TRANS/WP.29/GRSP/2005/5
9 March 2005

PROPOSAL FOR DRAFT AMENDMENTS TO REGULATION No. 16
(Safety-belts)

Transmitted by the expert from France on behalf of the ad hoc group

Note: The text reproduced below was prepared by an ad hoc group in order to authorize the use of an acceleration test device for validation of the dynamic behaviour of a safety-belt.

DESCRIPTION OF CURVE OF TROLLEY' S, DECELERATION **OR ACCELERATION**,
AS FUNCTION OF TIME
(~~Curve for testing stopping devices~~)

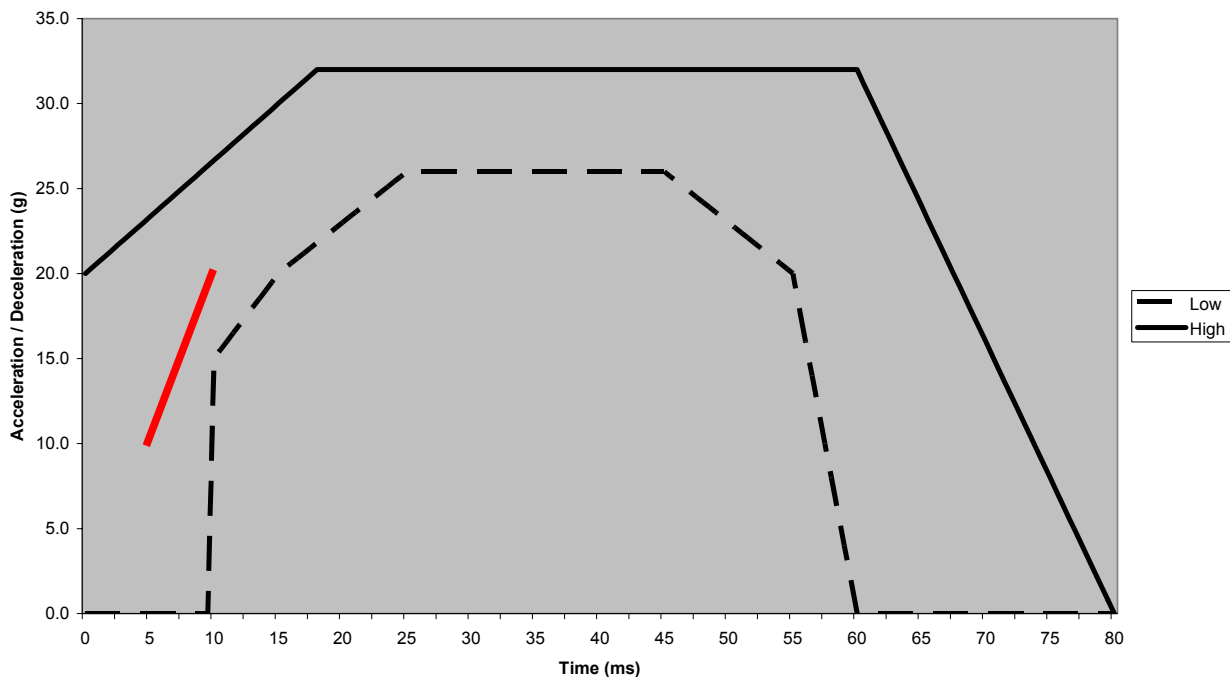
The trolley shall be so propelled that, during the test, its total velocity change ΔV is [51 km/h $\begin{smallmatrix} +2 \\ -0 \end{smallmatrix}$ km/h] and its acceleration curve is within the hatched area of the graph in annex 8, and stay above the segment defined by the coordinates [10g, 5ms] and [20g, 10ms]. The trolley shall remain horizontal during the acceleration. The distance to achieve the first [50 km/h $\begin{smallmatrix} +1 \\ -0 \end{smallmatrix}$ km/h] of the velocity change of the trolley shall be of [40 cm \pm 5 cm]. The start of the impact (T0) is defined, according to ISO DIS 17 373 for a level of acceleration of 0.5 g.

Annex 8, amend to read:

Parts of annex 8 have been put in paragraph 7.7.4. in order to use the same annex 8 for the two test devices (acceleration and deceleration).

As it can be seen in the table below, the actual pulse corridor permits a wide range of velocity change if there is no defined impact speed.

It is for that reason that a velocity change of 51 km/h has been defined for the acceleration test device. This variation of speed corresponds to the nominal curve and also to actual variation of speed on deceleration test devices including impact speed plus rebound speed.
